Swanzey Zoning Board of Adjustment
Meeting Agenda for January 27, 2025
7:00 p.m.

Memorandum – Office of Planning & Economic Development

RE: ZBA #24-013 & ZBA #24-014 – Tax Map 102 Lot 81

RE: ZBA #25-001 & ZBA #25-002– Tax Map 220 Lot 5

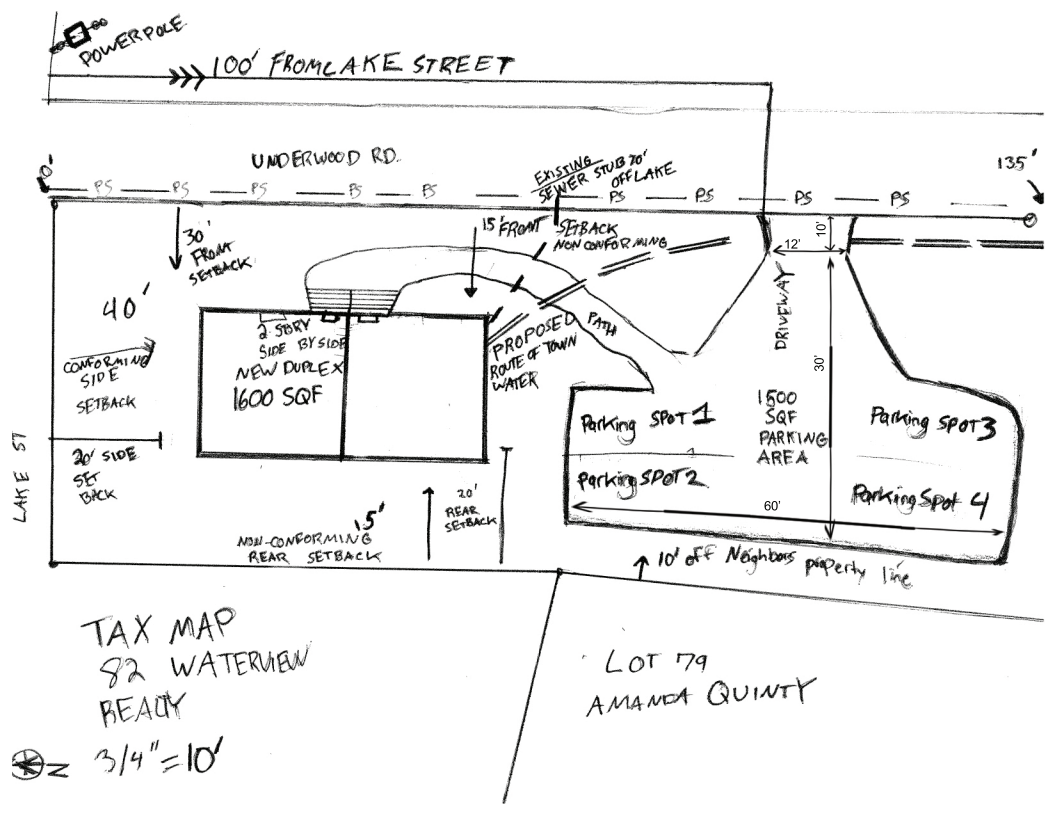
Joe DiRusso: Applicant is not adhering to the Driveway Regulations.

Eric Mattson: I think this building should be moved back away from the Lake St. side 20', to obtain a better distance from a busy street. The driveway should be south of the building again as Lake St is a very busy street throughout the day and night, any entrance and exiting onto Lake St. would be dangerous.

Planning Staff: We agree with the above comments from department heads. The structure and parking as presented do not adhere to adopted regulations and could be dangerous to drivers/pedestrians along Lake St.

SITE PLAN

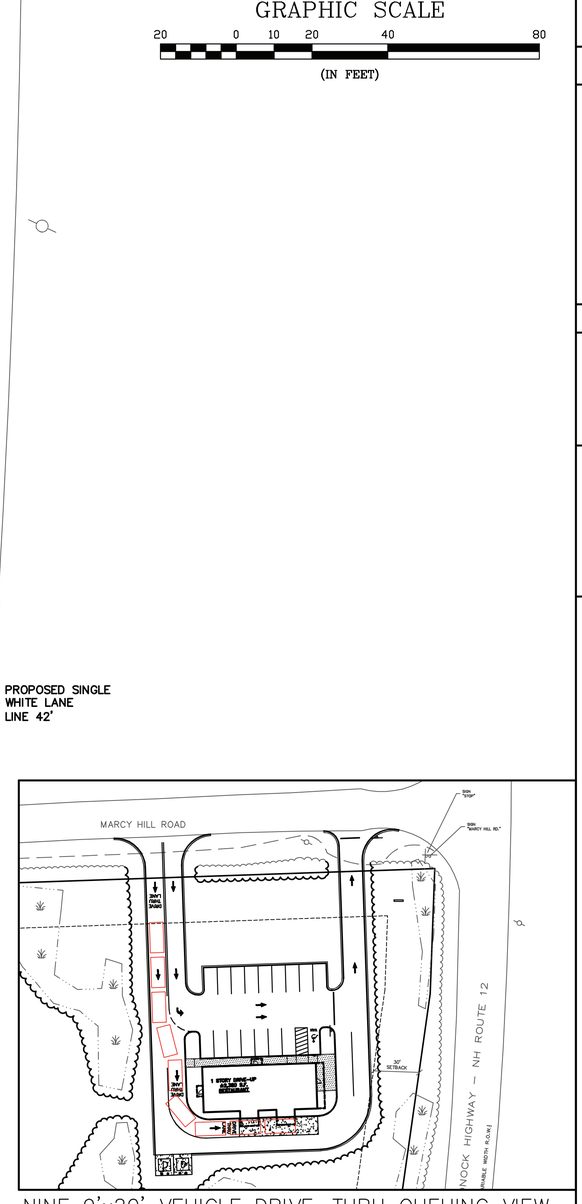
1. Granting the variance would NOT observe the spirit of the ordinance. The spirit of the Wetland Conservation District ordinance is to protect wetlands. Allowing a drive-in restaurant on top of a wetland that was filled in and dredged illegally in 1985 is not protecting wetlands. The front of this property is very wet—in the words of the applicant, "there are no areas on the property having a distance of 125 feet from any wetlands." I have walked the property, and flushed ducks near Rte. 12. This wetland drains to the South Branch, and any polluted groundwater here could also impact nearby wells. When asked, the applicant stated that the water table is less than a foot down—and this was during a drought. The property also appears to be sitting on top of one of the town's aquifers. The rear of the property however (not shown on the plot plan, as they plan to subdivide), is high and dry.

2. Granting the variance would NOT do substantial justice. In 1985, R & L Doody owned this property, and received a permit from the ZBA and State Wetlands Board to use 200 cu yds of fill and build a small convenience store. Instead, the Doodys dumped more than 4,000 yards of fill, illegally dredged the site, and applied to the town to add gas pumps. Their application was denied and the Army Corps instructed them to remove excess fill. It's unclear whether that was done. Since this project is proposed on a wetland that was illegally filled in, that fact should not be rewarded by allowing another developer to add more fill and build on that same spot. That would not be just. This property was only recently purchased, with the buyer knowing full well about the wetland frontage on Rte. 12. The rear of the property is NOT affected by wetlands issues and could be developed in a different way.

3. The special condition distinguishing this property is that indeed it is very wet along Rte. 12, and there are no areas having a distance of 125 feet from any wetlands on the Rte. 12 frontage—but that is not the case in the back of the lot. The other special condition is its history, as noted above.
